Re: Comments on the Roosevelt Irrigation District (RID's) "Operation and Maintenance Plan – RID Wellhead Treatment Systems" (Synergy October 2013-Revision 3)

COMMENTS: OPERATION AND MAINTENANCE PLAN – RID WELLHEAD TREATMENT SYSTEMS, REVISION 3

## **PROCESS FLOW DIAGRAM RID-89 WELL HEAD TREATMENT SYSTEM**

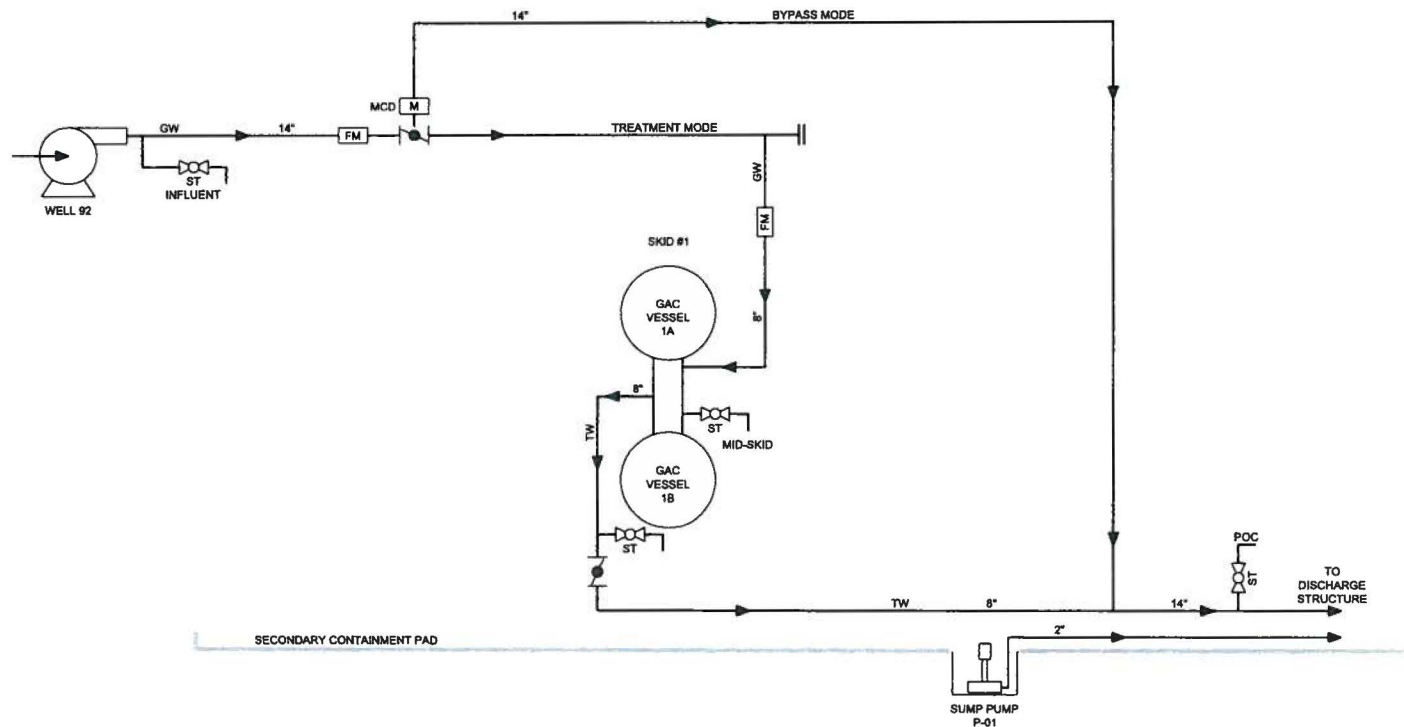
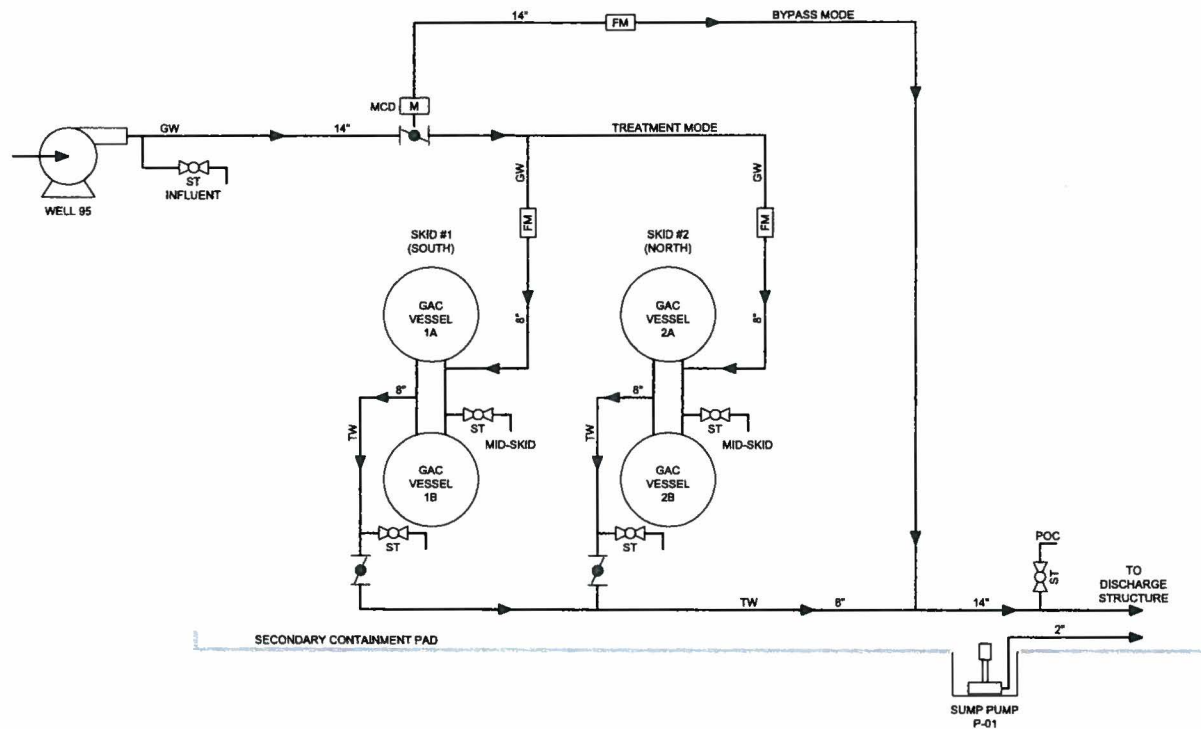
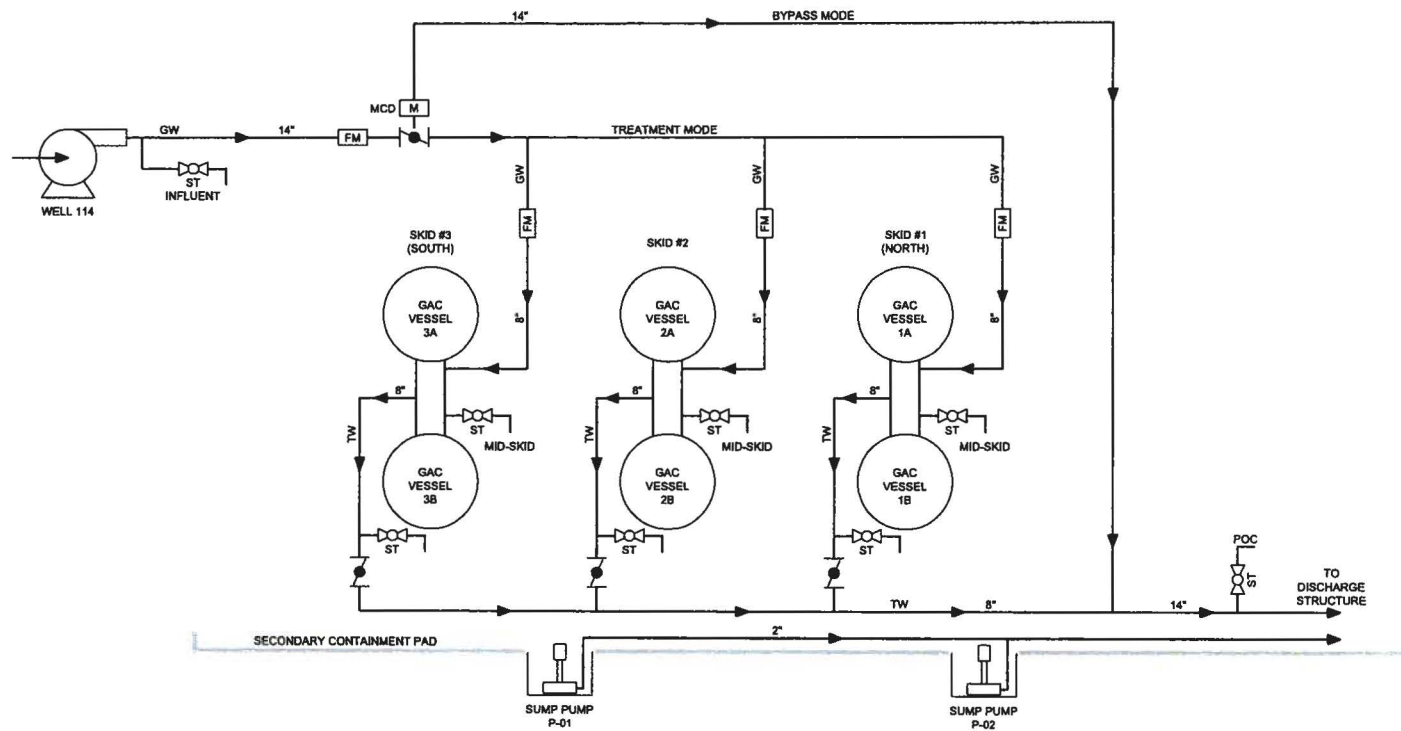
information should be included in 7.0 Key Contacts List in the event the I&C require troubleshooting support in the future.
6.	<b>4.5 Instrumentation and Controls</b> Figures 2 thru 5 provide general process flow information for each wellhead treatment system. The O&M Plan should be revised to include Piping and Instrumentation Diagrams (P&ID) as well or in place of the process flow diagrams.
